Technical Service Bulletin

87 Faint noise heard in cabin from air conditioning circuit

87 24 68 2044717/10 March 8, 2024. Supersedes Technical Service Bulletin Group 87 number 19-93 dated July 12, 2019 for reasons listed below.

| Model(s) | Year | VIN Range | Vehicle-Specific Equipment |
|------------|-------------|-----------|----------------------------|
| S6, and S7 | 2014 – 2018 | All | Not Applicable |

Figure 1. The low side line that needs to be replaced.

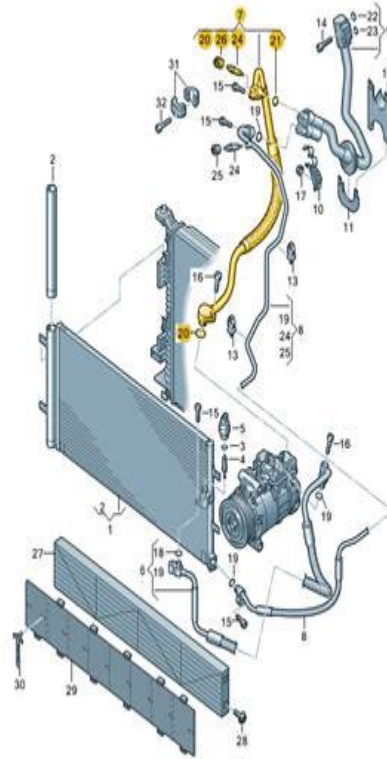
1. Replace the low side refrigerant line that connects the air conditioning compressor suction port to the hybrid refrigerant line to the expansion valve (Figure 1). Be certain to use new O-rings at these and all refrigerant circuit joints that are disconnected.

Figure 2. Balance weight position on the low side line.

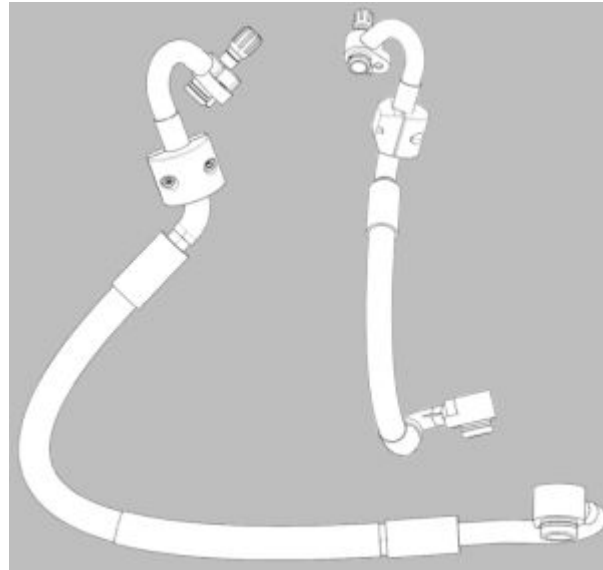
2. Install the balance weight (part number 4G0513621A) with 2 bolts (part number N 10653601) to the line in the position shown in the illustration (Figure 2).
